**REGION-TO-AREA SCREENING METHODOLOGY
FOR THE
CRYSTALLINE REPOSITORY PROJECT**

APRIL 1985

**U.S. DEPARTMENT OF ENERGY
OFFICE OF CIVILIAN RADIOACTIVE WASTE MANAGEMENT
CRYSTALLINE REPOSITORY PROJECT OFFICE**

STATE COMMENTS ON DRAFT REGION-TO-AREA
SCREENING METHODOLOGY DOCUMENT AND CRP RESPONSES

Figure 3 Crystalline Repository Project Report Schedule Leading to Initiation of Area-Phase Field Work

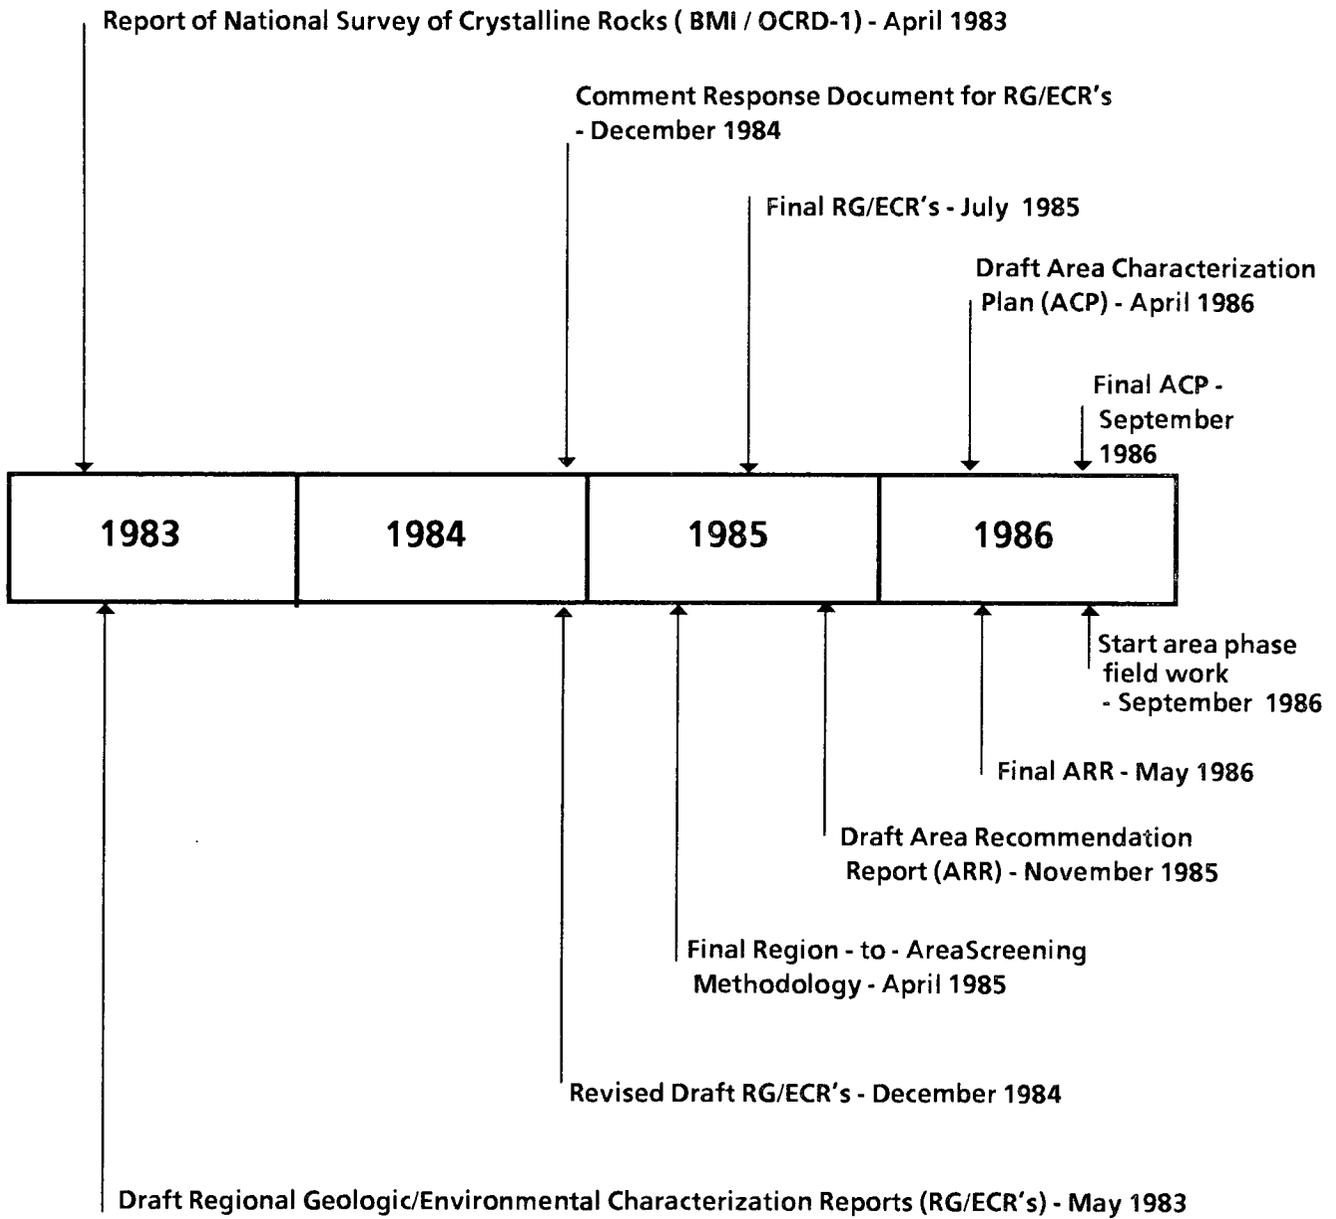
Figure 3 is no longer valid, as Comment Response Document for RE/GCR's not released in September, 1984.

Figure 3 has been modified to reflect the current CRP schedule through the initiation of area-phase field work.

Figure 8 Favorability Maps for Hypothetical Application of Environmental/Socioeconomic Step 2 Variables

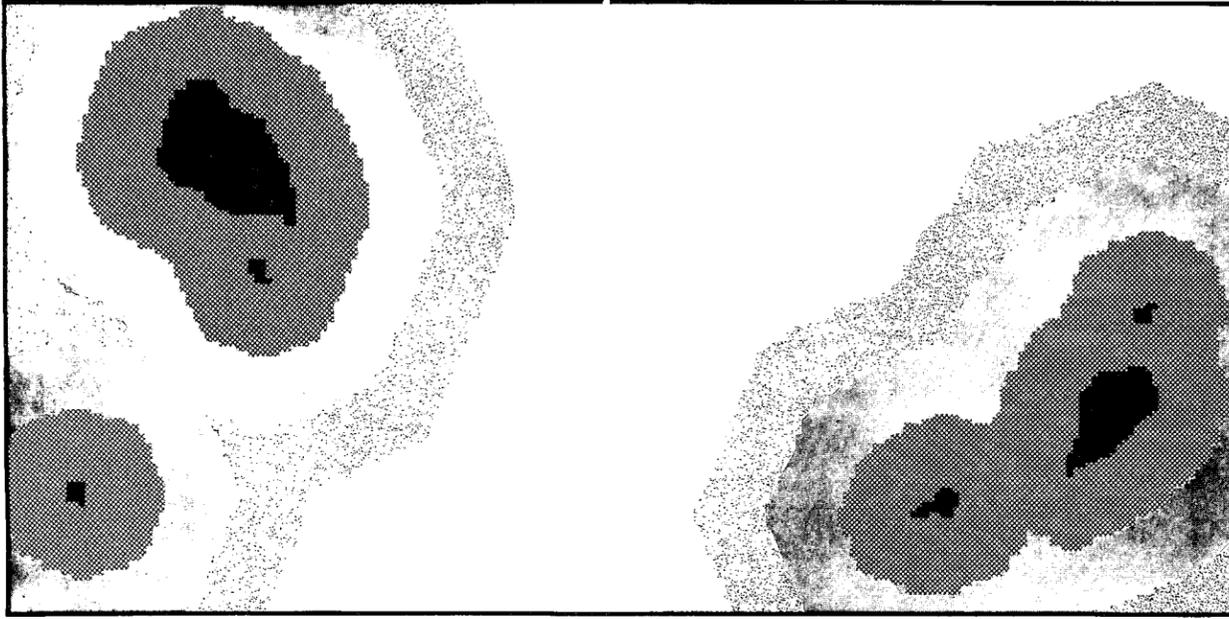
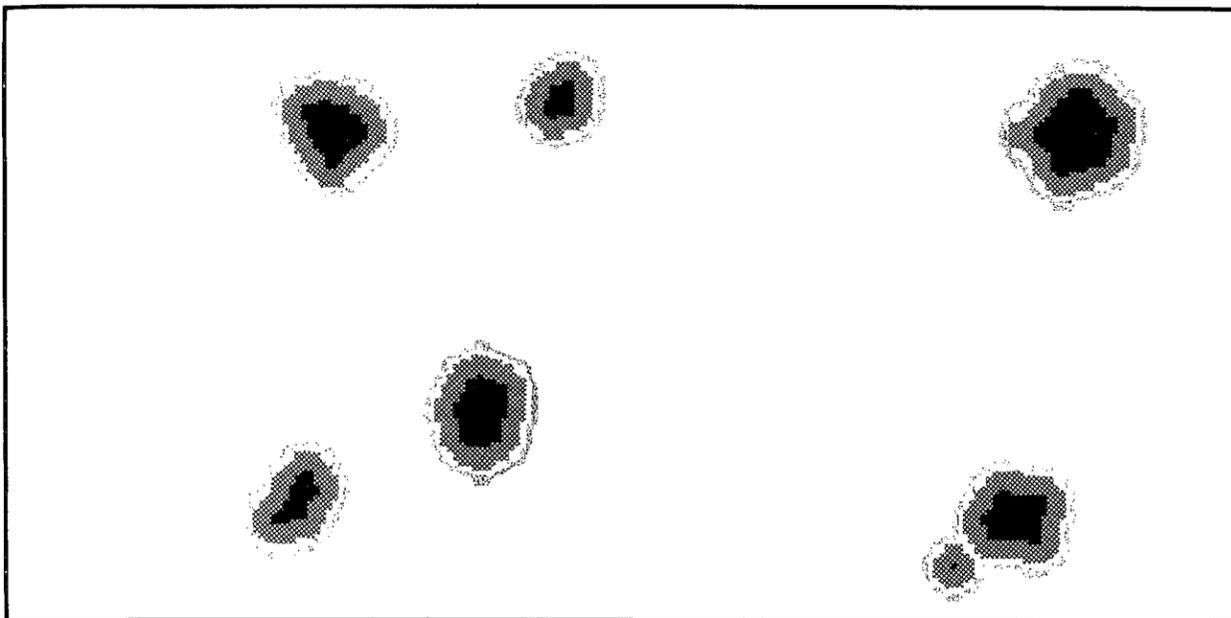
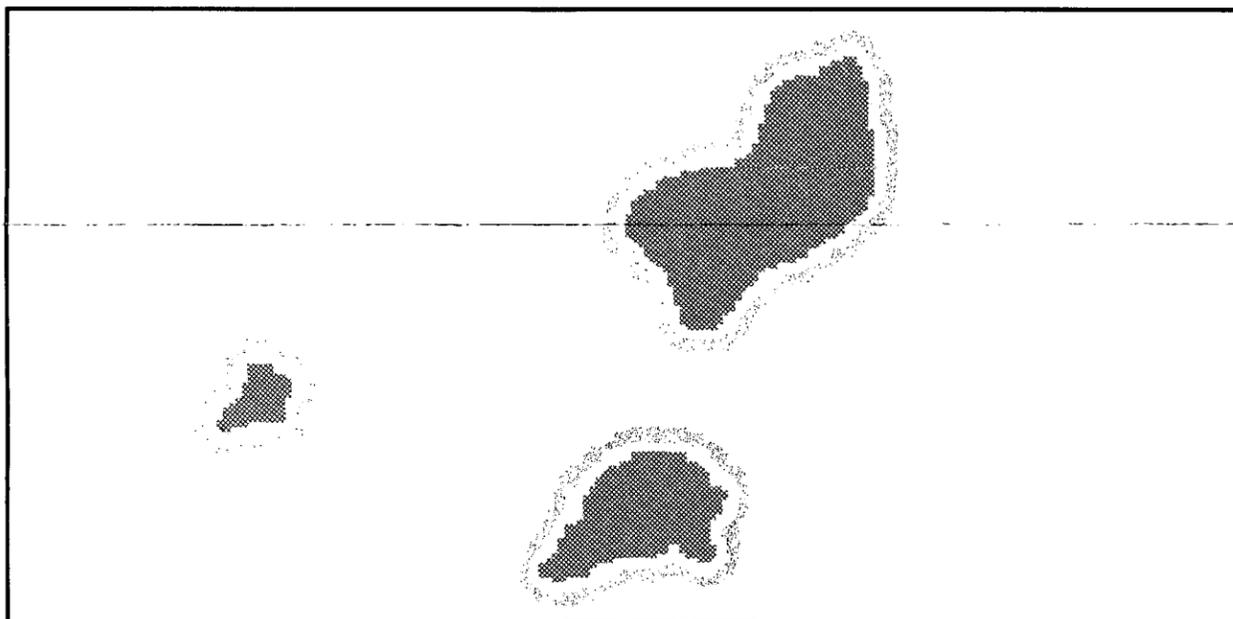
P. 24, Figure 8 - Why is shading for no. 2 darker than for no. 1? It would be logical for shading to become progressively lighter from no. 1 to no. 5. Also, it is difficult to distinguish in shading between "disqualified" and no. 2.

Figure 13 Schematic Diagram of Drainage Basin, Showing the Major Stream (Ground-Water Discharge Zone) and Drainage Divide

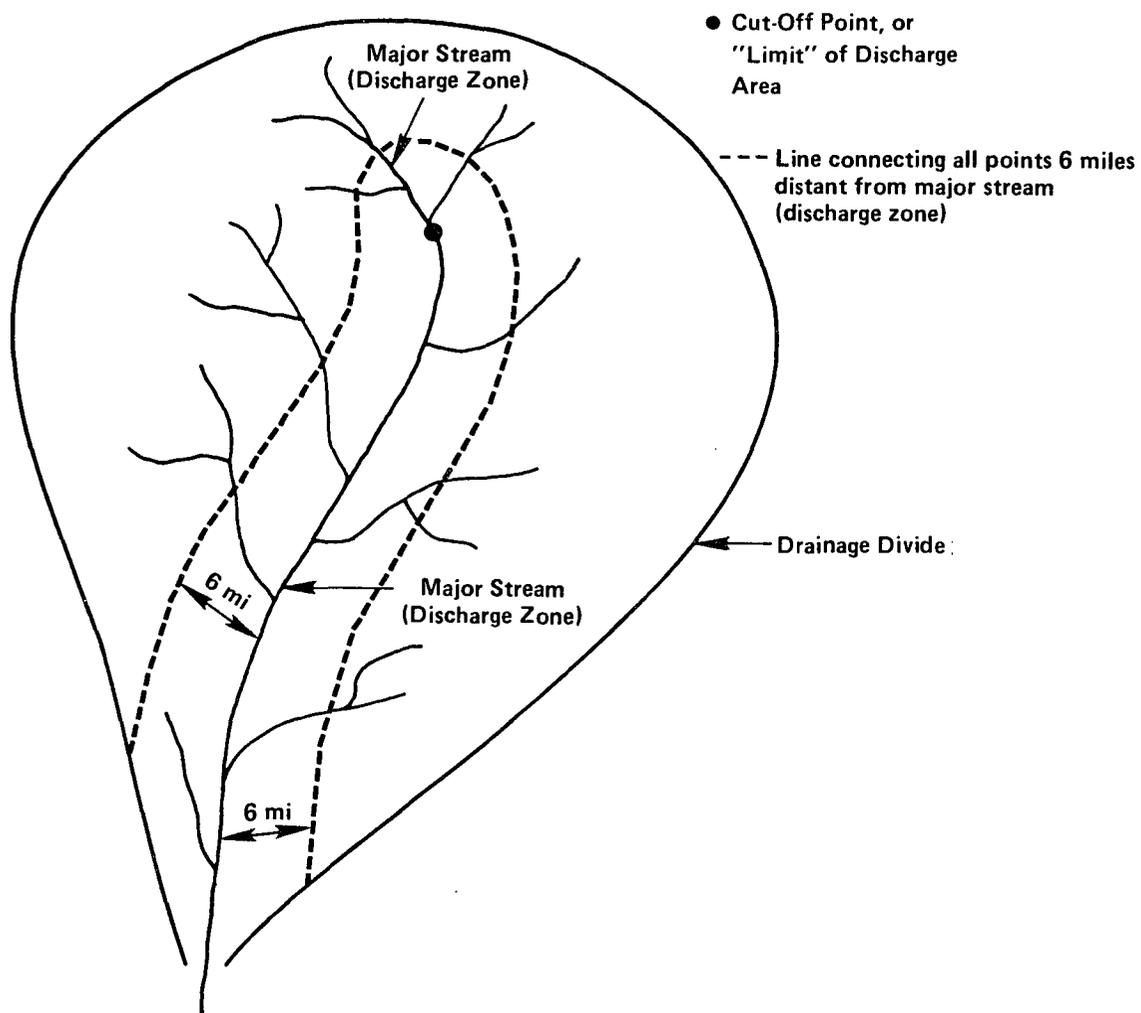
It is not clear to the uninformed reader what a "cut off point" is. Also, it would be helpful to label the "hinge line" on Figure 13.

This section has been rewritten, and the "cutoff point" is now explained. Figure 13 has been revised, and the "hinge line" is no longer used as part of the measure for the variable.
